Mayberry, Colorado Springs

Filing No. 3

Construction Drawings

MAYBERRY, COLORADO SPRINGS - FILING NO. 3

SPRINGS RD & MAYBERRY DR
MINI-ROUNDABOUT
PLAN & DETAILS

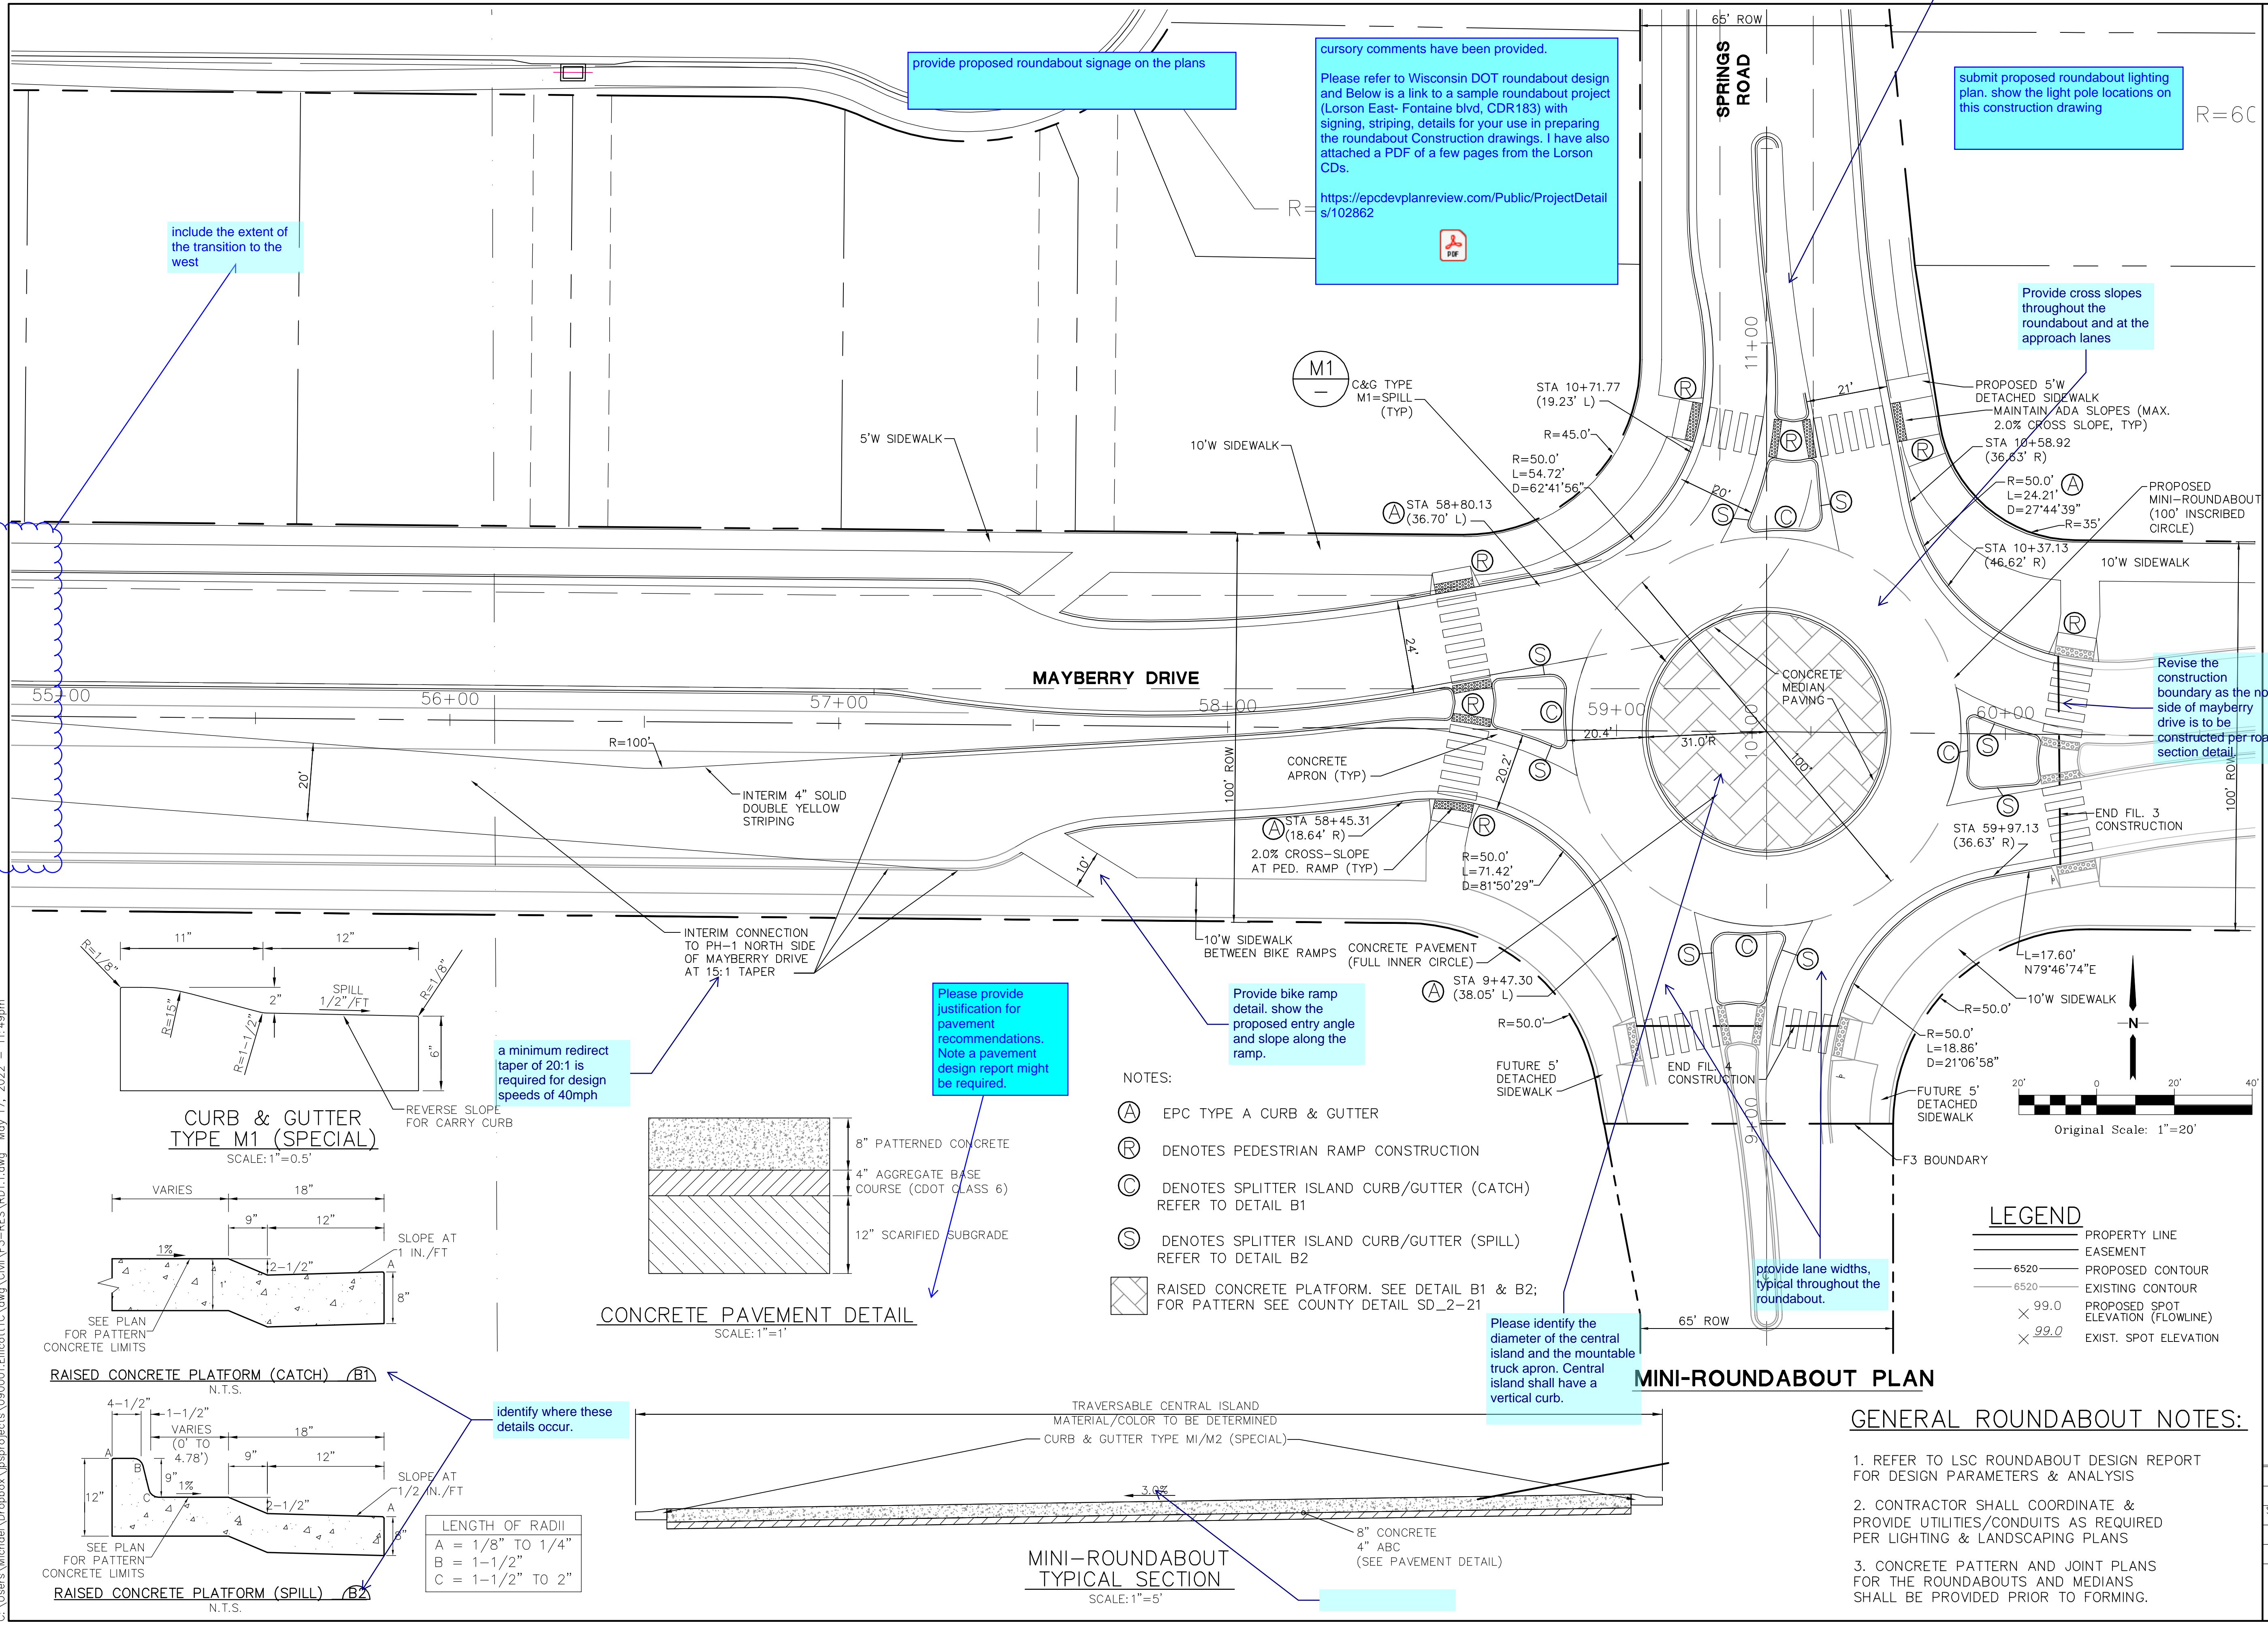
include the extent of the transition to the west

provide proposed roundabout signage on the plans

cursory comments have been provided.
Please refer to Wisconsin DOT roundabout design and Below is a link to a sample roundabout project (Lorson East- Fontaine blvd, CDR183) with signing, striping, details for your use in preparing the roundabout Construction drawings. I have also attached a PDF of a few pages from the Lorson CDs.
<https://epcdevplanreview.com/Public/ProjectDetails/102862>

submit proposed roundabout lighting plan. show the light pole locations on this construction drawing

Provide cross slopes throughout the roundabout and at the approach lanes

Revise the construction boundary as the north side of mayberry drive is to be constructed per road section detail

Please provide justification for pavement recommendations. Note a pavement design report might be required.

Provide bike ramp detail. show the proposed entry angle and slope along the ramp.

provide lane widths, typical throughout the roundabout.
